RANS

Assembly Alert: 189
Date: August 2, 2019
Subject: Station 4 – Additional Rivet Placement
Compliance: Mandatory
Models Affected: S-21 & S-21LS OUTBOUND

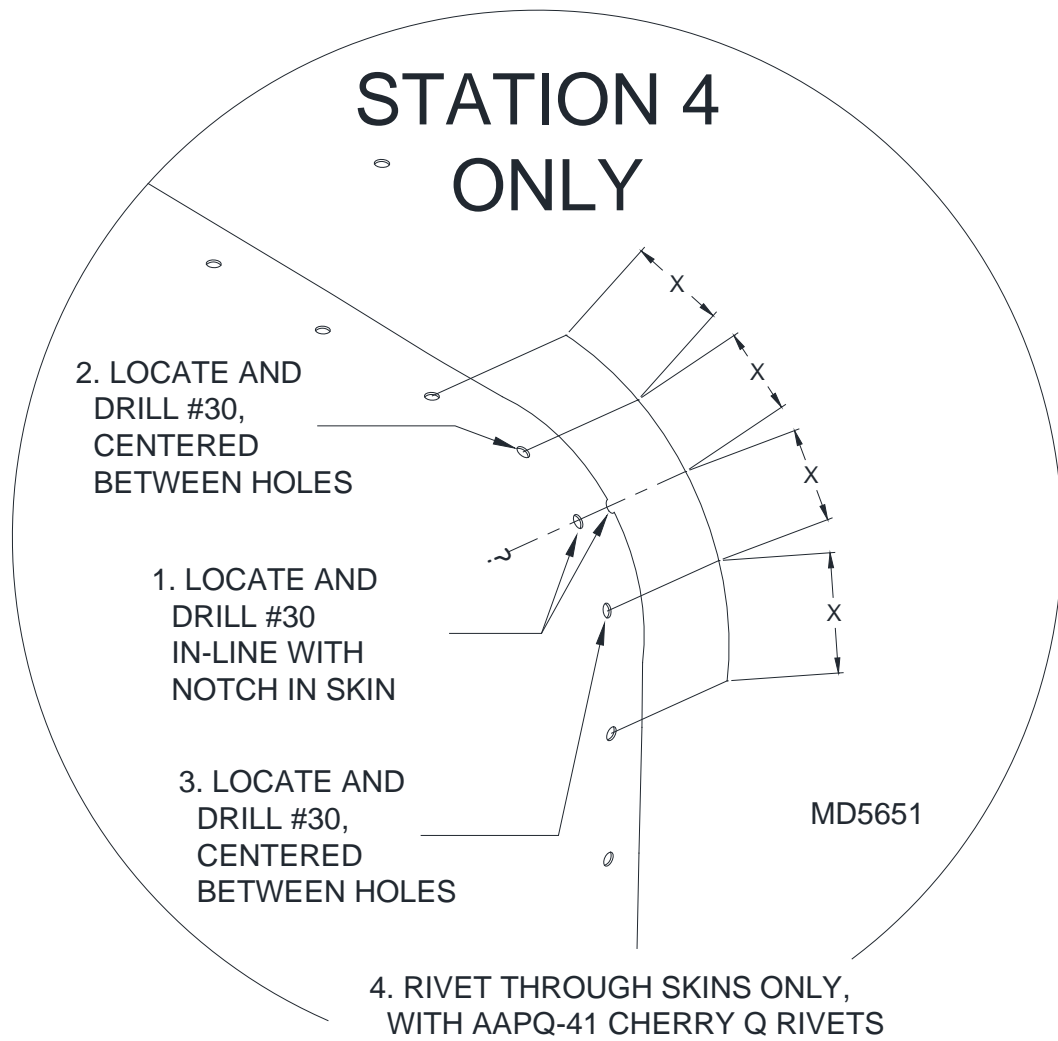
It has come to our attention that due to expansion and contraction of the Top Tailcone Skins at Station 4 against each other, paint may chip at the intersection.

Additional rivets may be installed to help prevent this.

Locate and drill #30 holes per drawing below. Use light pressure when drilling, since there is no bulkhead support underneath.

Deburr, remove drillings between skins and install AAPQ-41 Cherry Q rivets. The rivets will only penetrate the skins and not Bulkhead 4.

IMPORTANT: These additional rivets are **ONLY REQUIRED AT STATION 4** and should **NOT** be added to other stations.
